## **Addendum to the Concrete Batch Plant Control Plan**

### **Pipe Pile Seals Pier [REDACTED]**

TITLE OF PROJECT THE NEW NY BRIDGE	CONTRACT NUMBER D214134
LOCATION OF PROJECT MILEPOST 14.67 +/- IN ROCKLAND & WESTCHESTER COUNTIES

TITLE OF DRAWING  
APPROACH PRECAST  
PILE CAP TUBS  
SOFFIT FORM & ANNULAR  
SEAL CWP

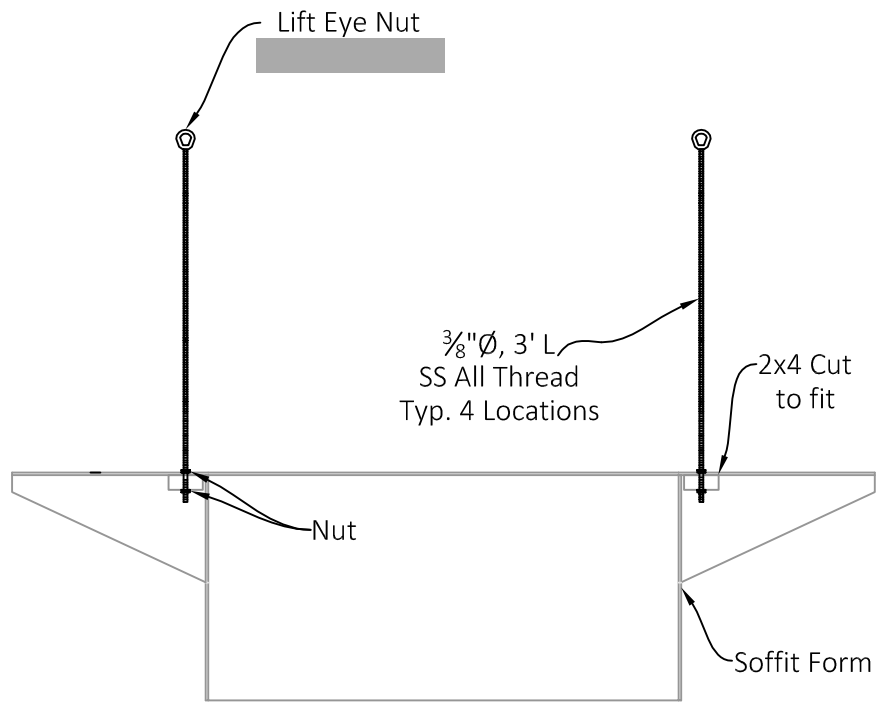
Appendix F of the Concrete Batch Plant Control Plan has been updated to include drawings of the [REDACTED] steel sleeves and the soffit panel work plan.

The following procedure will be used to secure the steel sleeves to the pre-cast concrete soffit panels:

1. Preference is to have the steel sleeves set 1-2 days prior to setting pre-cast concrete form ("tub"). Steel sleeves will be temporarily secured to the pile with ratchet straps during this time.

- a. If necessary to aid in installation a lubricant may be used to aid in placing the fiberglass sleeve onto the pile.
2. Steel sleeve will be supported by up to six 3/8"-inch diameter rods, connected through a 5/8" diameter hole in the flange of the sleeve and a three-inch steel angle below. Lifting eyes at the top of each rod will attach to a nylon ratchet strap to allow securing and adjustment.

3. After installation of the tub and prior to placing concrete, the steel sleeve will be inspected by crews to confirm the steel sleeve is properly placed and making positive contact to the pre-cast tub per the plan.

- a. If, based on the inspection by the crew, a void is observed the crew will attempt to further secure the steel sleeve to the pre-cast tub.
  - b. If, based on the inspection by the crew, the steel sleeve shows evidence of large deflection and/or displacement, inspection and adjustment from below may be necessary, such as addition of friction collars, backer rods or similar sealing material.

4. Crews will place one to two inches of sand into the annular space between the pile and pre-cast tub.
5. Filter fabric, or similar, will be placed over the 6-inch floor valves prior to placement of concrete.

6. Crews will continue to monitor the steel sleeve during placement of concrete to confirm that the engineering controls are effective and functional.
  - a. If the filter fabric becomes clogged or impairs the valve's ability to maintain hydrostatic equilibrium within the pre-cast concrete tub it may be replaced or removed to prevent undermining the structural integrity of the tremie seal as it cures.

7. Observations of turbidity extending outside of the steel sleeve will be communicated to the site foreman who will implement corrective actions as appropriate. Corrective actions that could be taken are, but not limited to, the following:

- a. Stop placement of concrete
  - b. Add additional backer rod, rope, or similar to fill observed gaps
  - c. Tighten rods and ratchet straps
  - d. Pre-inspection of upcoming piles for evidence of gaps and voids

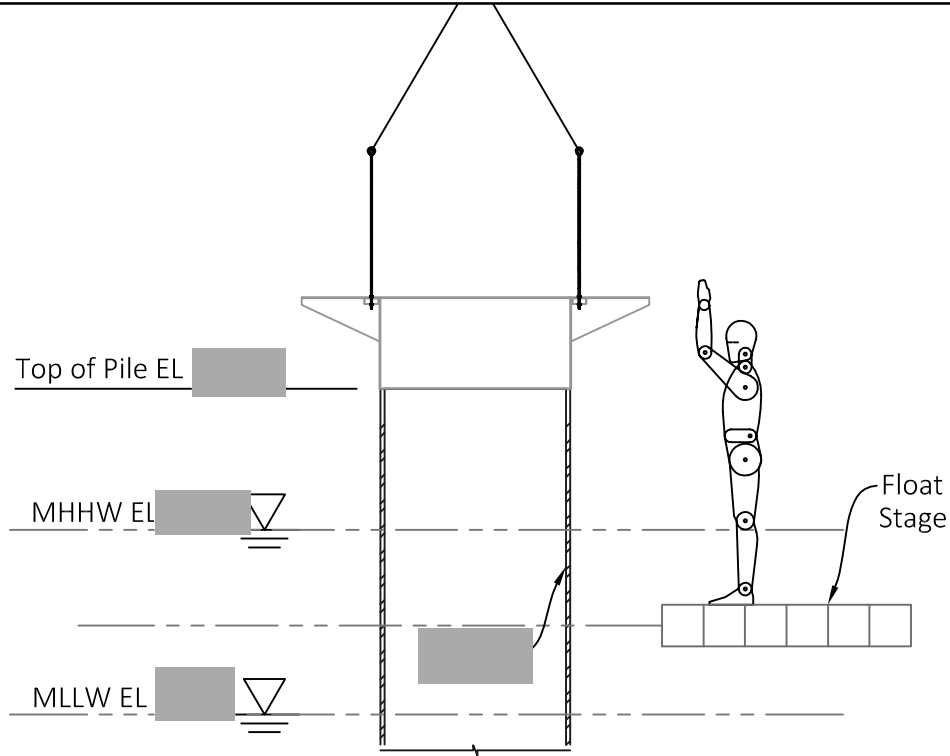
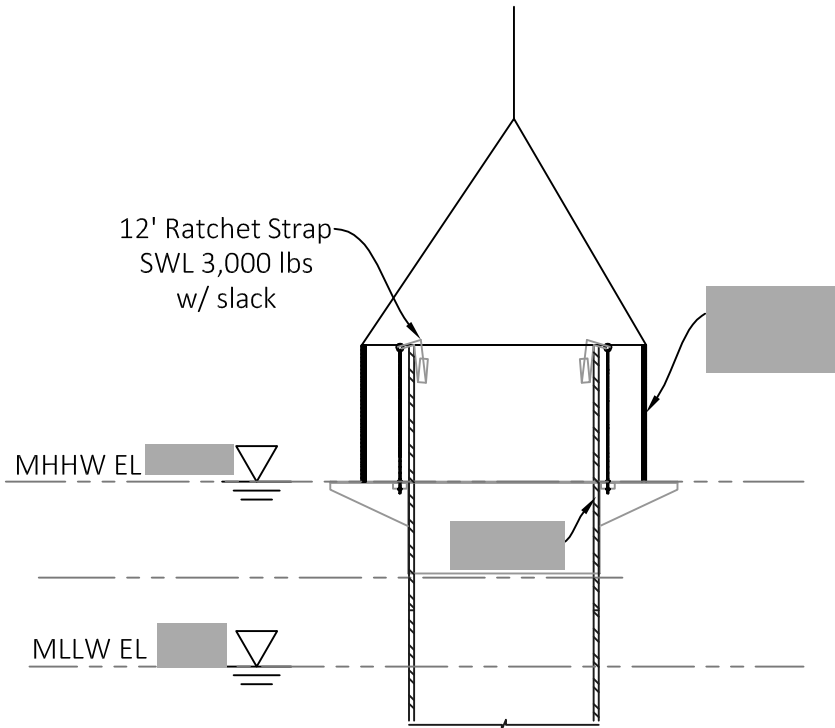
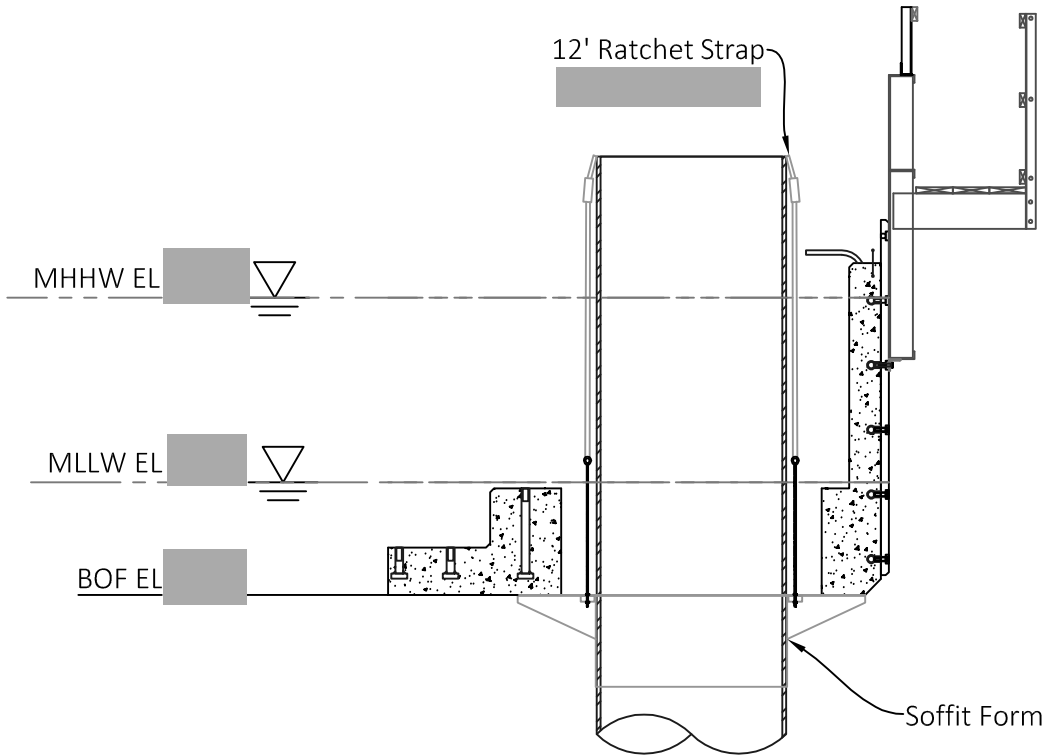
Appendix F of the Concrete Batch Plant Control Plan has been updated to include drawings of the [REDACTED] fiberglass sleeves and the soffit panel work plan.

The following procedure will be used to secure the fiberglass sleeves to the pre-cast concrete soffit panels:

1. Preference is to have the fiberglass sleeves set 1-2 days prior to setting pre-cast concrete form ("tub"). Sleeves will be temporarily secured to the pile with ratchet straps during this time.

- a. If necessary to aid in installation a lubricant may be used to aid in placing the fiberglass sleeve onto the pile.
2. Fiberglass sleeve will be supported by four 3/8"-inch diameter rods, connected through a 5/8" diameter hole in the flange of the sleeve and a 2x4-inch timber chock, cut to fit, below. Lifting eyes at the top of each rod will attach to a nylon ratchet strap to allow securing and adjustment.

3. Prior to placing concrete the fiberglass sleeve will be inspected by crew members to confirm the fiberglass sleeve is properly placed and affixed to the pre-cast tub per the plan.

- a. If, based on the inspection by the crew, a void is observed the crew will attempt to further secure the fiberglass sleeve to the pre-cast tub.
  - b. If, based on the inspection by the crew, the fiberglass sleeve shows evidence of large deflection and/or displacement, inspection and adjustment from below may be necessary, such as addition of friction collars, backer rods or similar sealing material.

4. Crews will place one to two inches of sand into the annular space between the pile and pre-cast tub.
5. Filter fabric, or similar, will be placed over the 6-inch floor valves prior to placement of concrete.

6. Crew members will continue to inspect the fiberglass sleeve during placement of concrete to confirm that the engineering controls are effective and functional.

- a. If the filter fabric becomes clogged or impairs the valve's ability to maintain hydrostatic equilibrium within the pre-cast concrete tub it may be replaced or removed to prevent undermining the structural integrity of the tremie seal as it cures.

7. Observations of turbidity extending outside of the fiberglass sleeve will be communicated to the site foreman who will implement corrective actions as appropriate. Corrective actions that could be taken are, but not limited to, the following:

- a. Stop placement of concrete
  - b. Add additional backer rod, rope, or similar to fill observed gaps
  - c. Tighten rods and ratchet straps
  - d. Pre-inspection of upcoming piles for evidence of gaps and voids
